Re: Approval in part of Red Hill AOC SOW Deliverable under Sections 6 & 7 - Monitoring Well Installation Work Plan

Attachment 1
Regulatory Agency Comments on April 29 2016 Monitoring Well Installation Plan,
Red Hill Bulk Fuel Storage Facility

Subject: Board of Water Supply (BWS) Comments to the Monitoring Well
Installation Work Plan, Red Hill Bulk Fuel Storage Facility

Figure 1
 Geologic Cross-Section Through Halawa Valley from Wentworth (1942)

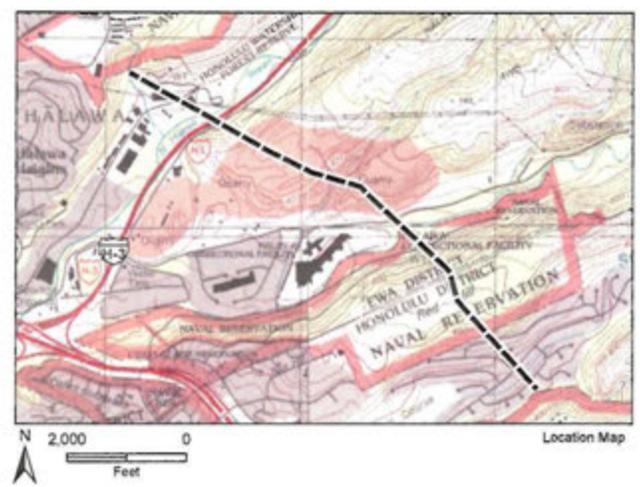
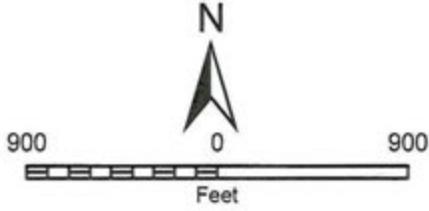
- 1) Figure 3 depictions of the assumed width and depth of the valley fill and saprolite in the North and South Halawa valleys do not take into account all available data; thus are misleading and could lead to incorrect choices for proposed well locations. Even if the authors of the MWIWP had relied only on Sherrod et al. (2007) or Stearns (1939), the depicted widths of Halawa valley fills are exaggerated by at least 50% beyond those sources. A brief physical visit to South Halawa valley will reveal that deep valley fill (greater than 50 feet in thickness) is confined only to the eastern branch of South Halawa Stream and does not extend to the western branch. The depicted depths of valley fill and saprolite also appear exaggerated and Figure 3 should be revised to reflect Plate 1 of Izuka (1992) and Figure 25 in Wentworth (1942). The enclosed Figure 1 to this letter reproduces the relevant part of Wentworth's Figure 25, which shows two end members, A and B, for the depth of valley fill in the two valleys. Only one deep well (CWRM Deep Monitoring Well HDMW2253-03) has been installed in this area of Halawa valley since Wentworth (1942) and this well appears to intersect the eastern part of the South Halawa valley fill.

Figure 2
Suggested Alternative Location for RHMW09

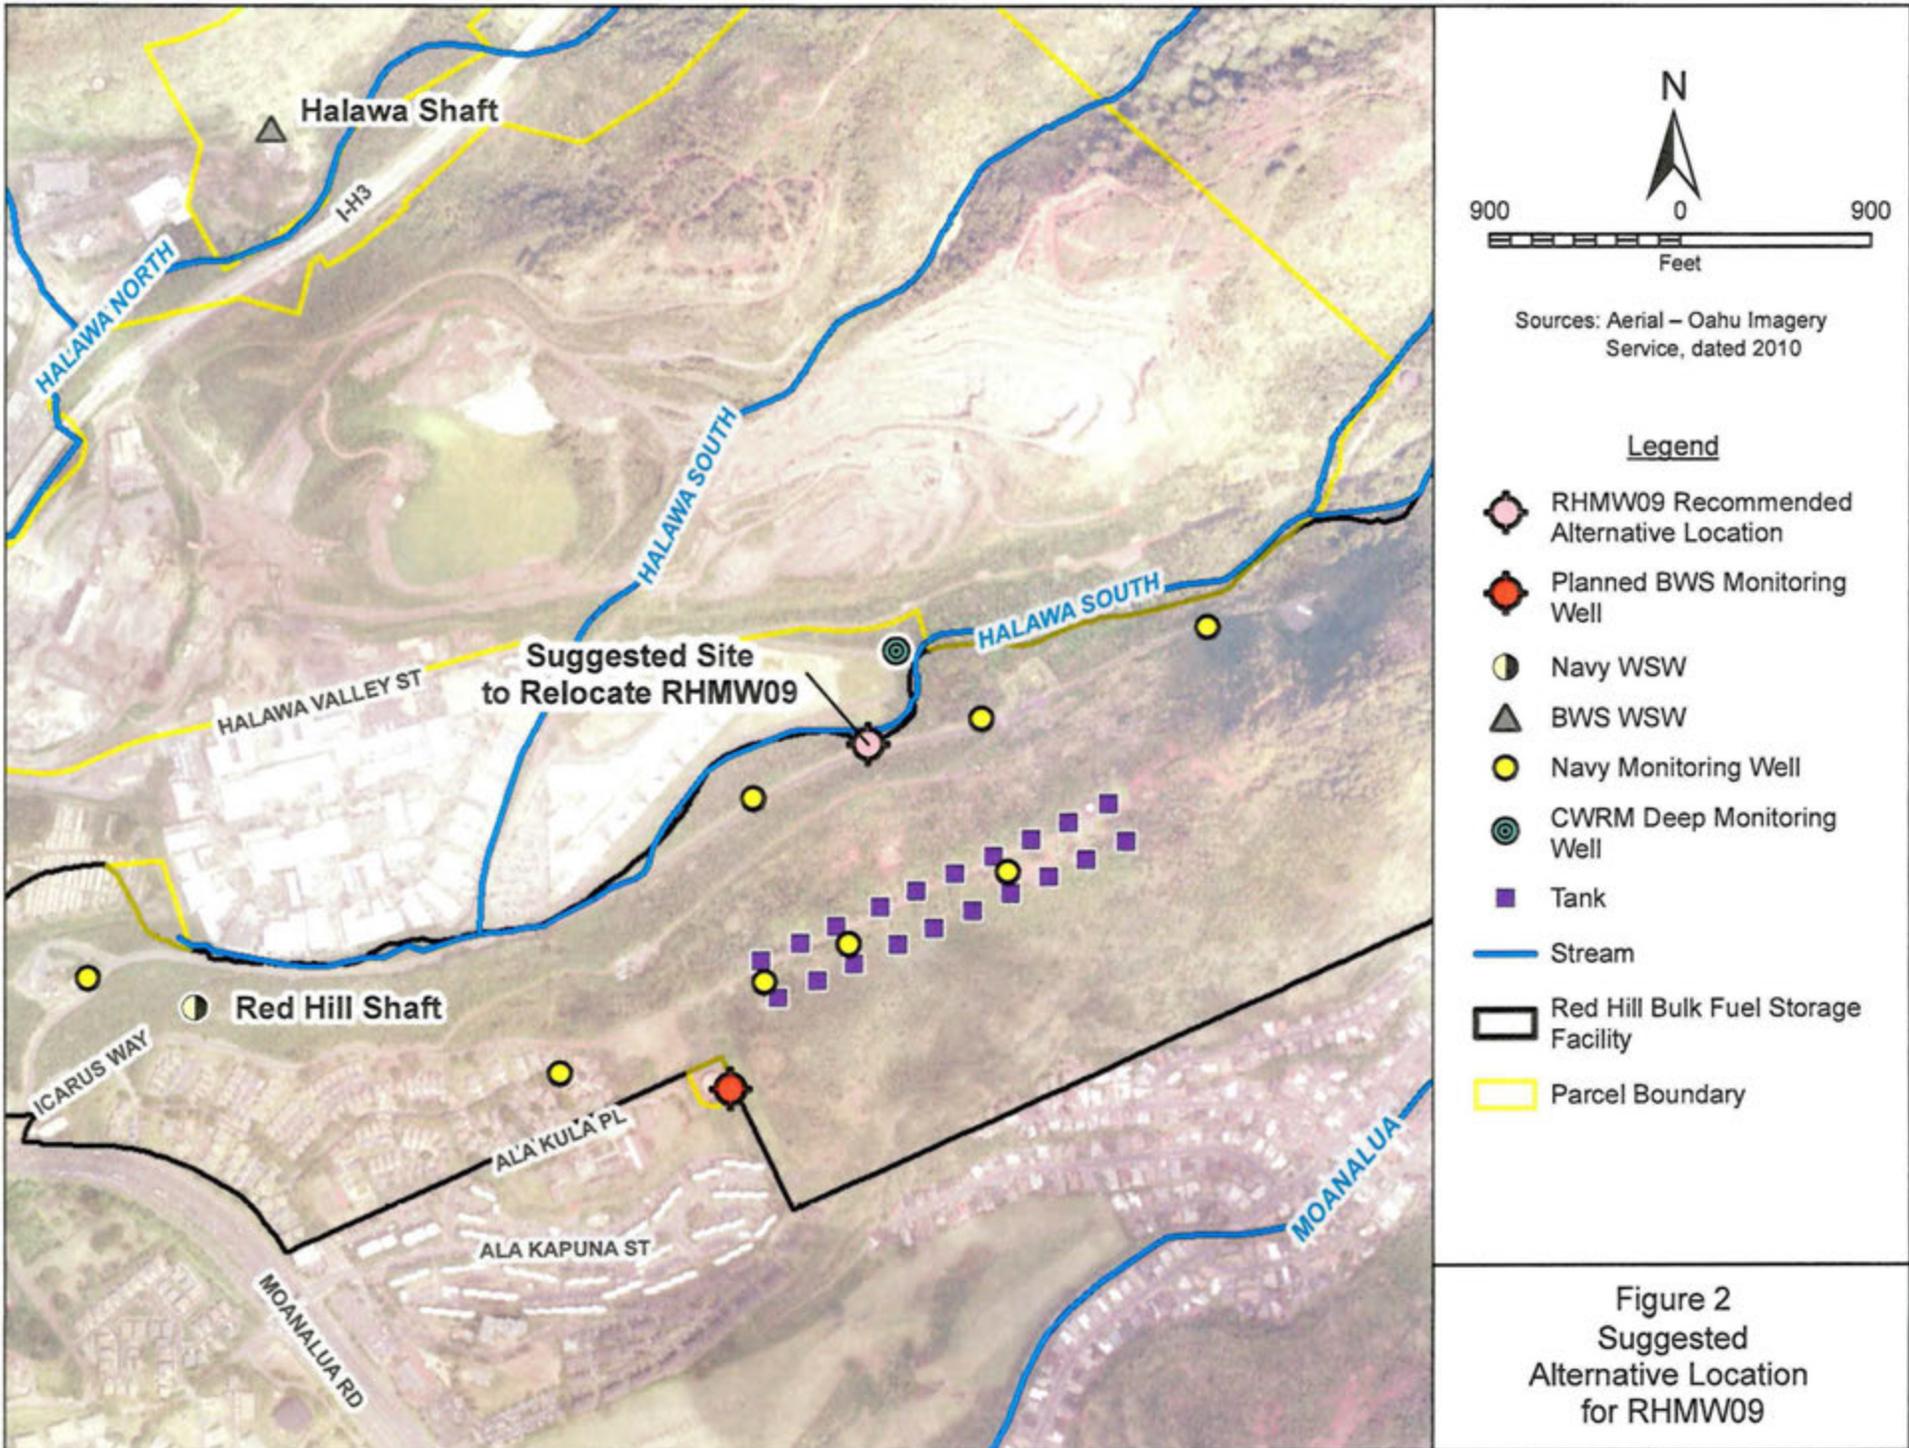
- 2) The proposed monitoring well Red Hill Monitoring Well (RHMW) 09 location is in very close proximity to a monitoring well being planned to be installed by the BWS. We recommend re-locating RHMW09 to the south side of Halawa Valley, along South Halawa stream, within the Red Hill Bulk Fuel facility boundary, such as the location shown in the enclosed Figure 2.
